Chapter 12 Discussion Topics List

Chapter 12 Radiation Protection, RAIs 8254, 8275, 8353, 8247, 8098, and 8389 Conference Call with KHNP on APR1400 Design Certification Wednesday, May 18th, 2016, 7:00 p.m. – 9:00 p.m. (EST)

Figure 12.3-17 Radiation Zones (Normal) Turbine Building El. 73'-0"

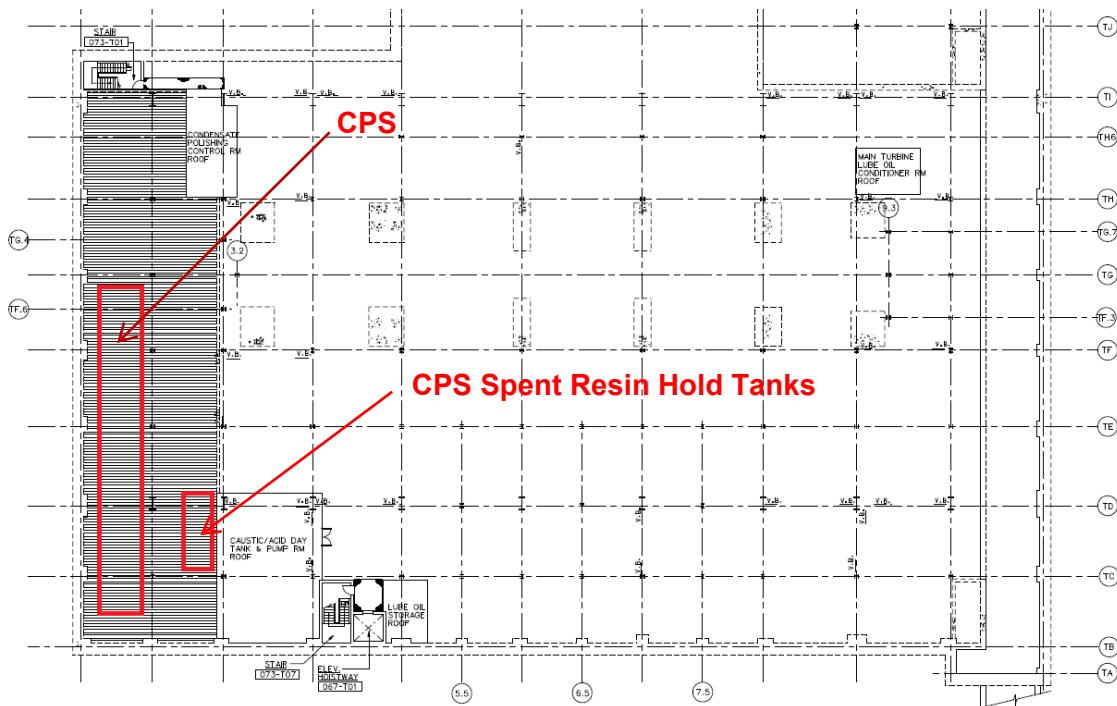
(NRC Status) Also, this was not discussed during the call but the CPS demineralizers and spent resin holding tank area do not appear to be identified in the Chapter 12 radiation zone maps for the Turbine Building. The DCD should be updated to identify and zone these areas properly in the DCD Chapter 12 figures. The response to Question 12.02-15 should be updated to include this information. (RP)

(KHNP Response) Radiation zone maps for Turbine Building are provided in DCD Figures 12.3-17 and 12.3-18. As shown below, the radiation zone at EL. 73'-0" is designated as Zone 2 and this area contains CPS demineralizers and the spent resin hold tanks. Shielding is provided around this area. Since no description is provided in Figure 12.3-17, KHNP will update this figure to include that this area contains CPS demineralizers and the spent resin hold tanks as a revised response to RAI 141-8098 Question 12.03-8.

Figure 10.4.10-1 (Sheet 3 of 3) will be revised as shown below:

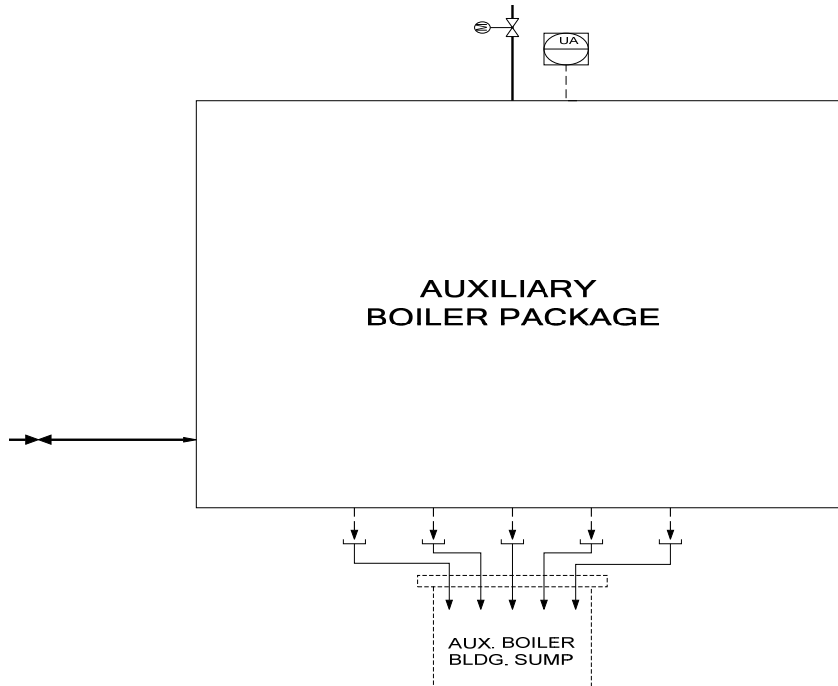
a) First, it appears that monitoring for potentially radioactive fluid in the Auxiliary Steam System occurs prior to the fluid reaching the Auxiliary Boiler Package (apparently this is done by monitor RE-103, according to DCD Table 11.5-2) and if the system contains radioactive fluid, it is routed to the radwaste system prior to entering the Auxiliary Boiler Package. See Figure 10.4.10-1 (Sheet 2 of 3), which shows monitoring of the Auxiliary Steam System after the condensate receiver tank and an optional line to the liquid radwaste system prior to reaching the Auxiliary Boiler Package on Sheet 3 of 3. Therefore, it is unclear if the Auxiliary Boiler Blowdown would be expected to potentially contain radioactivity levels requiring treatment. More importantly, it is also unclear that the description of the blowdown drains in the DCD is accurate and that it will actually connect to the Liquid Waste Management system. While the response to RAI 8321, Question 09.02.02-9, adds a COL item specifying that the COL applicant is to provide the flow diagram of the turbine generator building drain system and the CCW heat exchanger building drain system, DCD Section 9.3.3.2.6 already indicates where the lines run. It states:

The above language implies that the design will include lines from the Auxiliary Boiler Blowdown to the sumps and apparently interconnecting the different sumps in the Turbine Building. Is this information in the DCD accurate? (ME)

Therefore, the auxiliary boiler blowdown would be expected to potentially contain radioactivity levels requiring treatment, and DCD Section 10.4.10.2.3 will be added as shown below and Figure 10.4.10-1 (Sheet 3 of 3) will be revised as shown below sketch diagram. KHNP will revise the response to RAI 8326, Question 09.03.03-4.

“The auxiliary boiler blowdown and drains are routed to the Auxiliary Boiler Building Sump and then are routed to the TGB sump for radiation monitoring. When contamination level of the drains is detected exceeding a predetermined setpoint, they are routed to the LWMS for processing and release via the condensate polishing area sump.”
